ADDENDUM NO. 3

Project: American Legion Core Academic Renovation

**AMERICAN LEGION HIGH SCHOOL
CORE ACADEMIC AND CAMPUS RENOVATION
SACRAMENTO CITY UNIFIED SCHOOL DISTRICT
DSA App # 02-116158; DSA File # 34-H7**

ADDENDUM # 3 – REBID
July 25, 2018

DRAWN BY: NE
CHECKED: ST
DRAWING NO:
ADD-3R
A5/A-542

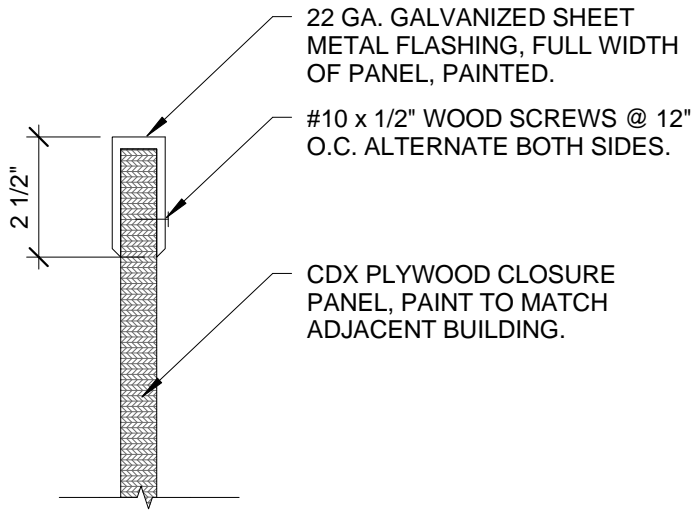
- A. Detail A5 – Closure Panel Detail: Add Detail **ADD-3R A5/A-542** – Closure Panel Detail to the contract documents. Refer to ADD-3R 1/GS102 for closure panel locations.
- B. Detail B4 – Closure Panel Section: Add Detail **ADD-3R B4/A-542** – Closure Panel Section to the contract documents. Refer to ADD-3R 1/GS102 for closure panel locations.

ST A5/A-592

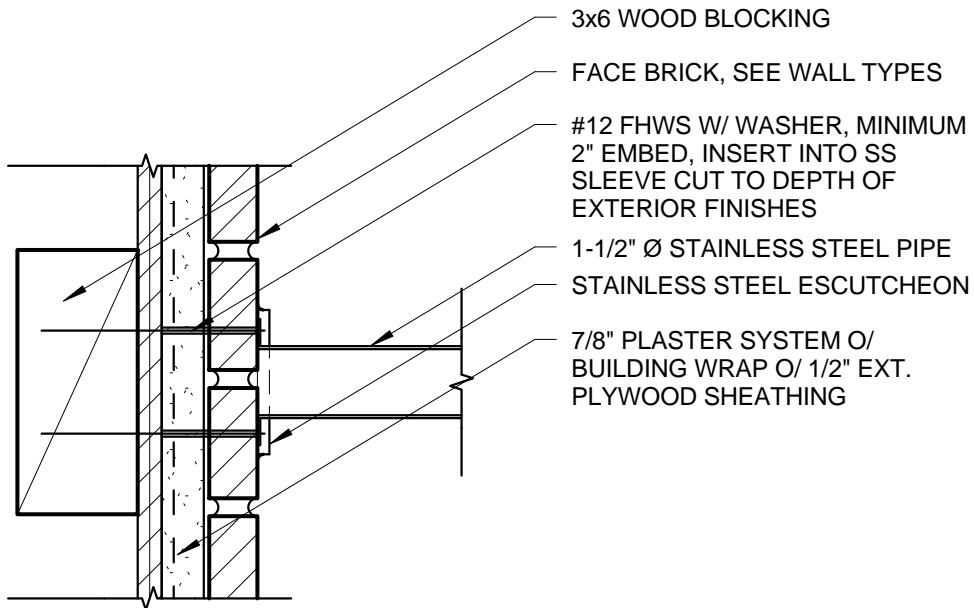
- A. Detail A5 – Wood Trim: Replace this detail with the attached **ADD-3R A5/A-592**.
- B. Detail D1 – Guardrail Wall Attachment: Add Detail **ADD-3R D1/A-592** – Guardrail Wall Attachment to the contract documents. Refer to D1/A-592 for drinking fountain rails; this detail shows the attachment of drinking fountain rails to wall.
